Tierra Del Este Unit Ninety Five

City Plan Commission — May 8, 2025 **[REVISED]**

CASE NUMBER/TYPE: SUSU25-00029 – Major Combination
CASE MANAGER: Alex Alejandre, (915) 212-1642, AlejandreAX@elpasotexas.gov
PROPERTY OWNER: Ranchos Real IV, Ltd.
REPRESENTATIVE: Conde, Inc.
LOCATION: South of Edgemere Blvd. and East of Tim Floyd St. (Extraterritorial Jurisdiction (ETJ))
PROPERTY AREA: 106.89 acres
VESTED RIGHTS STATUS: Vested (August 2008)
PARK FEES: Park Fees Not Required
EXCEPTIONS/MODIFICATIONS: Yes, see following section
ZONING DISTRICT(S): N/A property lies within ETJ

Figure A: Proposed plat with surrounding area

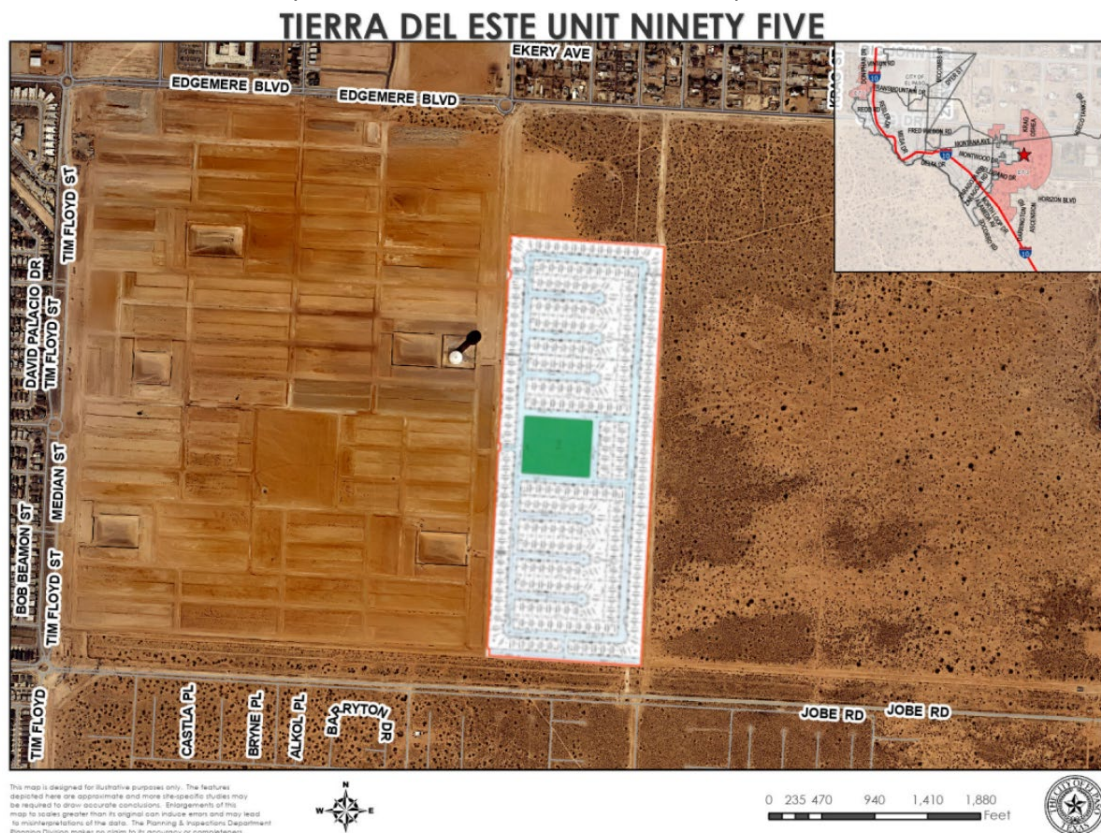
SUMMARY OF RECOMMENDATION: Staff recommends **APPROVAL WITH CONDITIONS** of Tierra Del Este Unit Ninety Five on a Major Combination basis, **and APPROVAL of the exception requests, subject to the following conditions:**

- That the applicant landscape the rear of all double-frontage lots, in accordance with Section 19.23.4(H)(3)(c) of the El Paso City Code.
- That Tierra del Este Unit Ninety Three subdivision shall be recorded prior to or concurrently with Tierra Del Este Unit Ninety Five Final Plat **in order to establish access to the subdivision.**

- To allow for Block 144 to have a street length or block segment in excess of 1,200 feet.
- To allow a connectivity index score of 1.1 instead of the required 1.4 for the subdivision.

ATTACHMENT 3

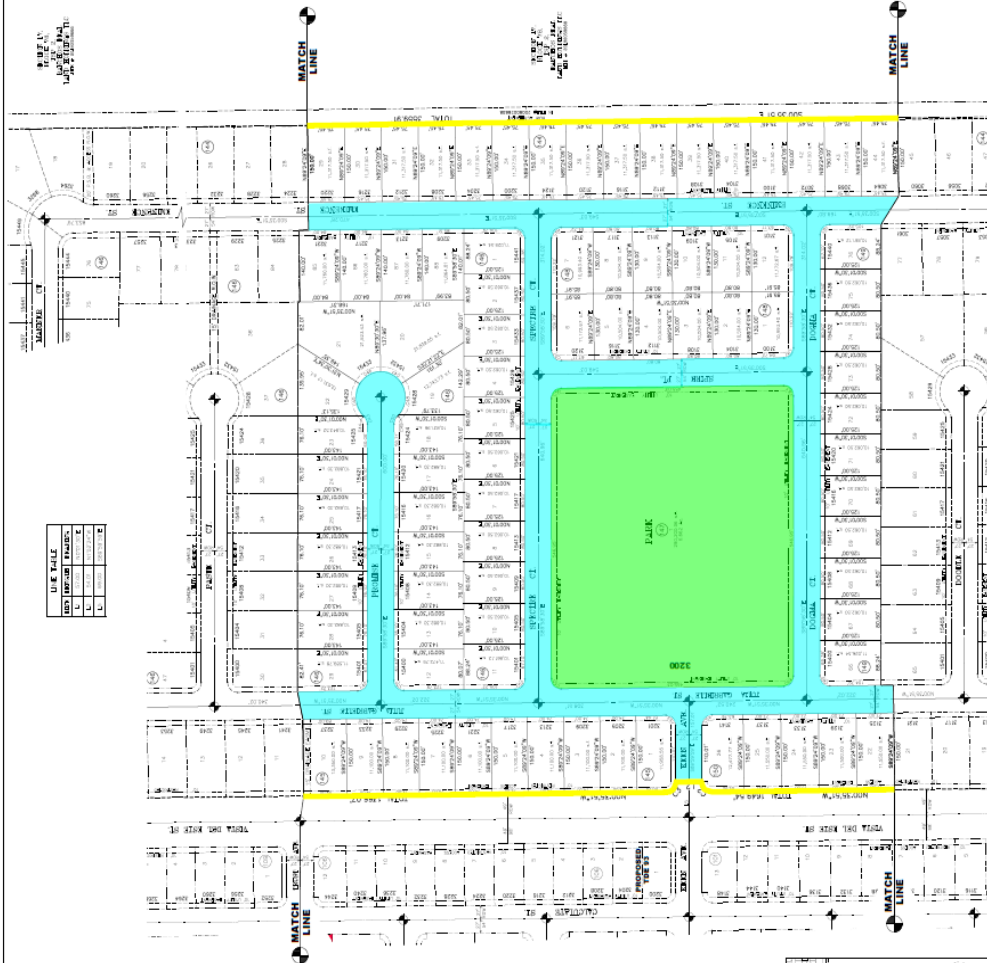
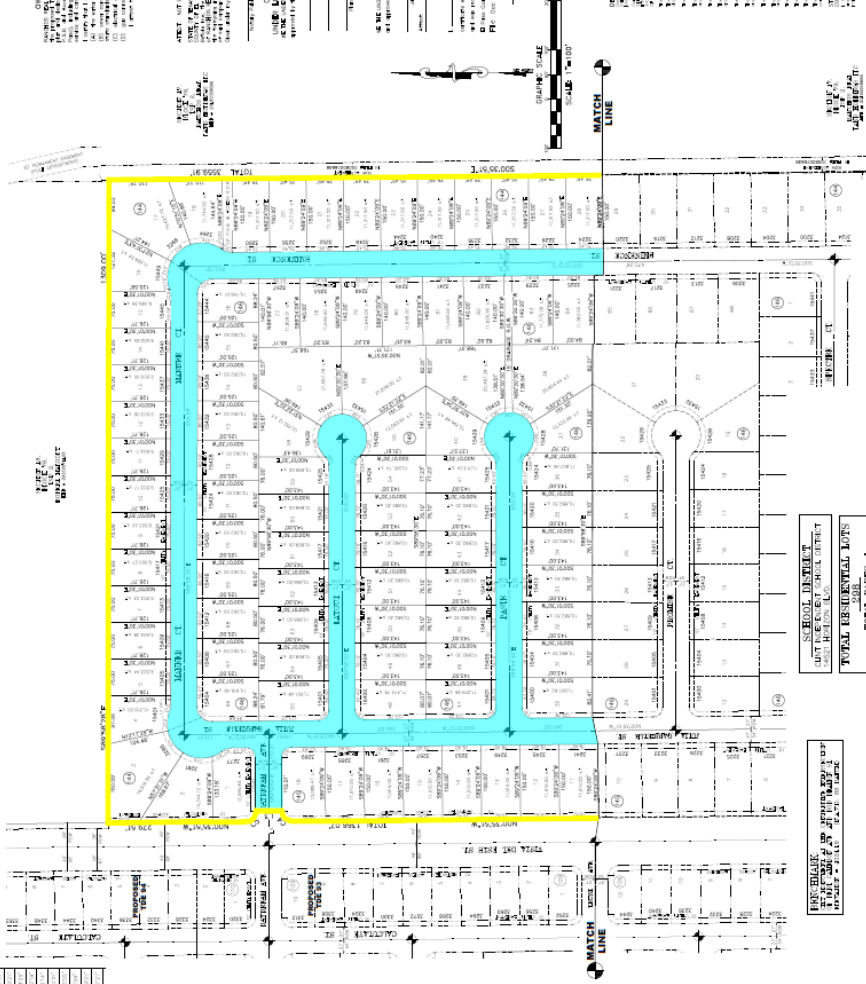
Developer / Engineer shall address the following comments:

1. Submit to the Planning & Inspections Department – Planning Division the following prior to recording of the subdivision:
 - a. Original copies of the tax certificate(s) with zero balance.
 - b. Park deed
 - c. Original copies of the restrictive covenants.
2. Staff recommends to the City Plan Commission (CPC) that the applicant landscape the rear of all double-frontage lots, as per section 19.23.040(H)(3)(c) of the applicable Subdivision Code.
3. Update ownership as per deed records on plats notes and all other statements.
4. Staff recommends to provide park deed and release of access documents as soon as possible for review.
5. Staff recommends to abbreviate the reference codes on El Paso County and City of El Paso approval statements to Local Government Code 212 and 232.

We have reviewed subject plats and recommend **Approval**. The Developer/Engineer shall address the following comments:

1. Provide subdivision improvement plans.
2. Provide print-out of the mathematical closure report is ok.
3. Coordinate the watershed area in acres and the Drainage I, II, III, and IV with the offsite areas in the subdivision in process “Tierra del Este Unit 93”, the proposed ponds for this subdivision shall have enough capacity to hold the developed runoff for a designated 100-yr. storm event.
4. Verify the Drainage report for “the two proposed retention basins located west of Vista del Este Dr. in the proposed Tierra del Este Unit 95 subdivision” instead of 93, please clarify.
